Traffic Calming Survey Results

The Murray CSO Control Project Design Advisory Group (DAG) members were asked to complete a survey ranking the traffic calming options under consideration for Beach Drive Southwest between Lowman Beach Park and the proposed facility. The chart below displays the average value of the ranking for each option. More preferred options were ranked higher and thus have a smaller bar. DAG members’ specific comments listed below the chart and on the back.

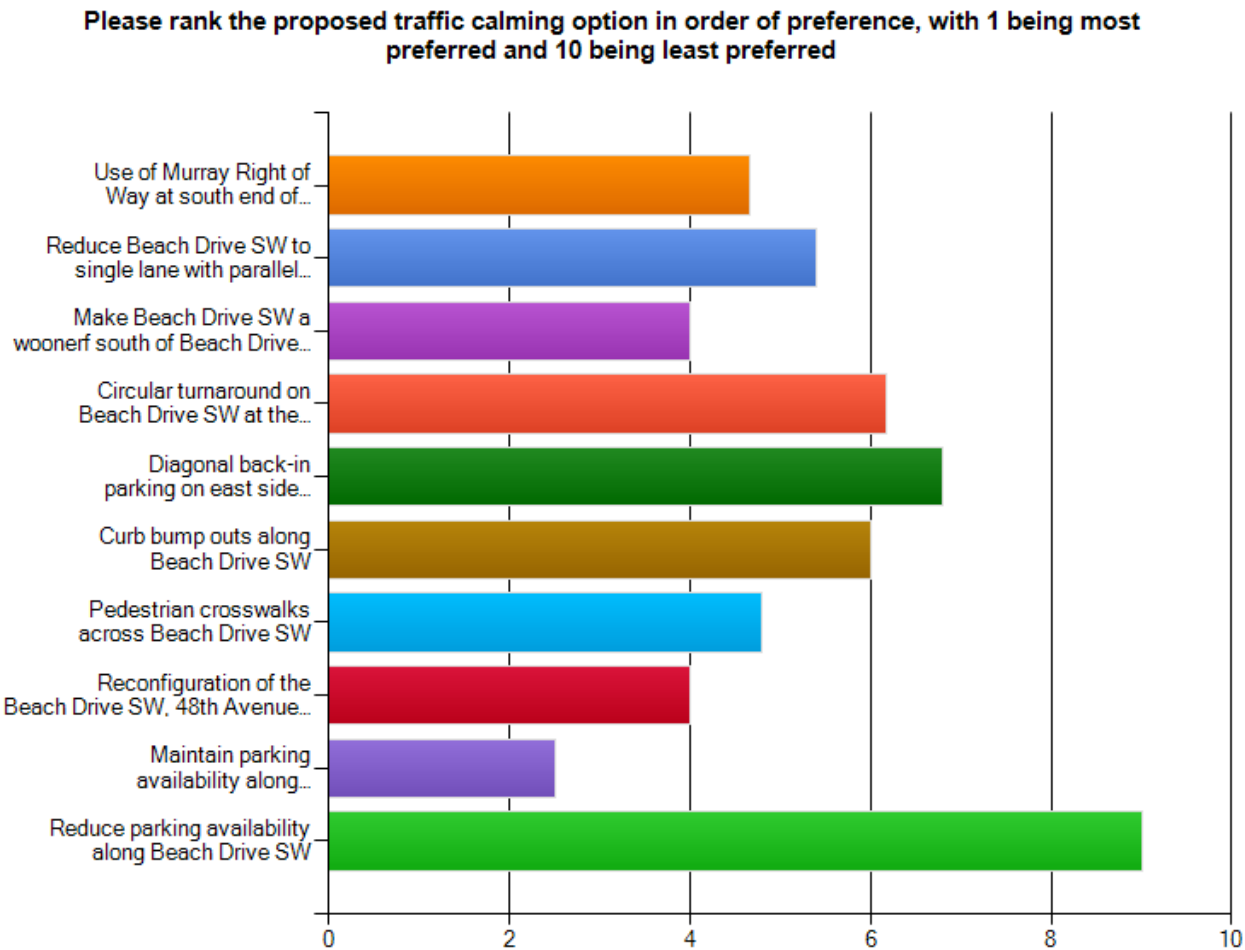
“The Murray right of way is already used for a sewer line; this line could be relocated as part of this project. The right of way could become a part of the footprint for the entire project, including the storage tanks, and facilities shown in draft plans as above ground that could be placed underground.”

"I liked the increased parking in #1; it takes pressure off the surrounding neighborhood and provides space for an expected increase in park usage (I prefer head-in to back-in parking). I think the places to discourage thru traffic are (1) at the entrance, by making the turn off of Beach Dr southbound, a sharper right turn than depicted and (2) at the south end of Lowman park where residences begin. The road (Beach DR) fronting the project suggested by SDOT and #3 is, I think, too narrow for easy traffic flow assuming traffic is discouraged as suggested above. I'm disappointed that SDOT didn't provide a preliminary sketch incorporating their criteria for our evaluation. Hopefully, a broader discussion will take place next week before you submit your proposal."

"I applaud the team for the attempt to reduce the actual and apparent size of the roadway (paved and impervious areas), and also appreciate the attempt to soften the right-of way as in the woonerf option. Several additional comments I hope can be studied: 1. The woonerf scheme shows a very large service access at the Murray Street right-of-way. I hope this can be reduced to the minimum requirement, or be significantly masked when the generator/odor structures are incorporated into the scheme (assuming they are pushed up against and incorporated into the grade retention strategies. 2. I would like to see the woonerf scheme advanced in a meandering pattern (as indicated) but with the sidewalks following a similar direction on both sides. This would alleviate the straight "hard edge" between the park and the right-of-way and potentially allow a better mediation of grades that would be more welcoming to the park and visually extend it to the east. 3. I know this is about traffic calming and not necessarily about landscape, but it has been proven that trees along the roadway are also calming devices. I would encourage the team to incorporate a regular rhythm of trees along Beach Drive to help define the street as a welcoming gateway to Lincoln Park. 4. Obviously the project has its physical boundaries, so it will be very important to establish clear transitions at the north and south to make sure that the design integrates well with the existing conditions along Beach Drive. The right-of-way that extends south from Murray is essentially unimproved, so careful consideration of that condition should be incorporated. 5. I would like to see some more definition of the parking spaces (beyond striping) within the road and/or woonerf scheme. Perhaps incorporation of bump-outs or landscaping to define and differentiate the roadway from the parking. 6. Following the woonerf direction, it would be interesting to study various curb configurations - from no curb, to rolled curbs to suggest more of a "lane" than a road. Paving or pattern options should also be considered. 7. I really look forward to the incorporation of the structure and retaining strategies into the road and site design. This will clearly inform the issues related to the service access, the incorporation of the structures into the retaining structures, and the potential for the buildings to be visually "below grade" with "living" roofs that can be accessible and part of a pedestrian realm that mediates the grade between Lincoln Park Way and Beach Drive. 8. Great start! Keep an open mind to doing this project in a manner that meets the functional and affordable criteria, but does so in new and creative ways that result in outcomes that none of us might have imagined going in."

"As a user of the park for launching my kayak, my top priorities are parking spaces and ease of access to hand-launch a boat at the beach. SDOT says less parking will not be a problem due to the homes being gone, but I'm skeptical of this. I like the turn-about at the South end, but if SDOT says turning around will not be a problem because you can use the facility maintenance road that is fine by me. I know the residents want to keep cars out with the one lane road, woonerf, etc., but as a park user I need to get my car in there to launch my kayak- so my interests oppose theirs. As for pedestrian crosswalks, I don't think they're necessary because it's not a busy enough street in my experience."
